TRANSMITTAL FOR RESOURCE CONSERVATION AND RECOVERY ACT FACILITY  
INVESTIGATION ADDENDUM SAMPLING PLAN FOR PREVIOUSLY UNINVESTIGATED  
SITES ZONE E CNC CHARLESTON SC  
11/19/2001  
CH2MHILL

Re: RFI Addendum Sampling Plan for Previously Uninvestigated Sites – Zone E

**Responses to SCDHEC Comments on the  
RFI Addendum Sampling Plan, Revision 0,  
Previously Uninvestigated Sites, Zone E  
Dated September 2001**

**Figure 7-2**  
 Historical Gas Station / Cafeteria Building Location  
 AOC 701, Zone E  
 Charleston Naval Complex

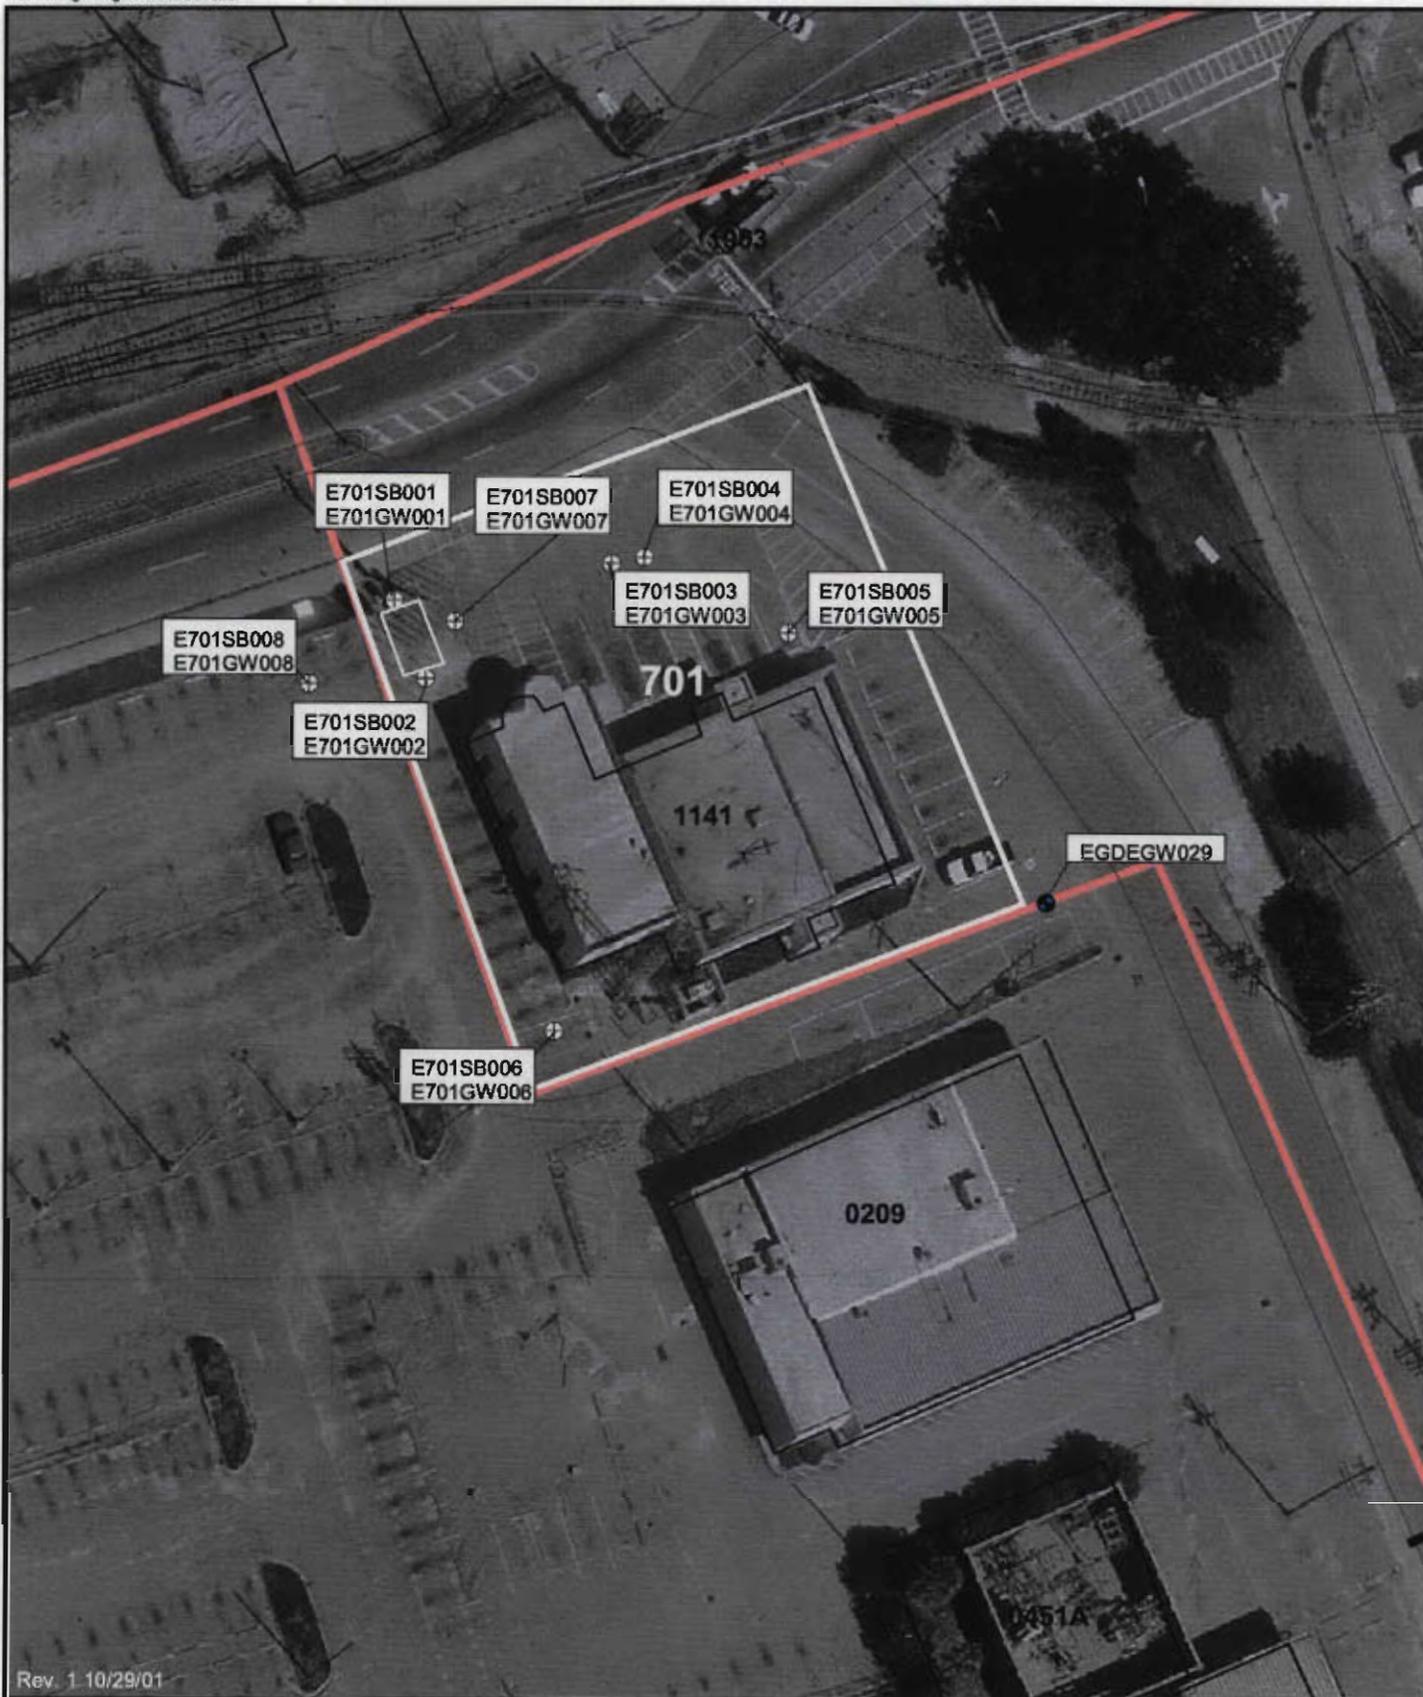
**Condition 1:** The Navy will field verify the location of the two closed USTs as the GIS data base depicts the tanks adjacent to the north side of Building 1141, which is different from the location depicted on Figure 7-2 of the Sampling Plan.

*The locations of the two USTs, as represented in the Sampling Plan, were based on information obtained from the RFA and the sampling activities conducted in 1997. However, further research into old construction drawings show that the tanks were actually located closer to the point represented in the GIS database, although that point is also not correct. A revised version of Figure 7-3 (formerly Figure 7-2) and a new Figure 7-2 showing the historical placement of the tanks and dispenser island have been prepared*

*for inclusion in the Sampling Plan. Copies of the revised figures are attached as Attachment A to this response to comments.*
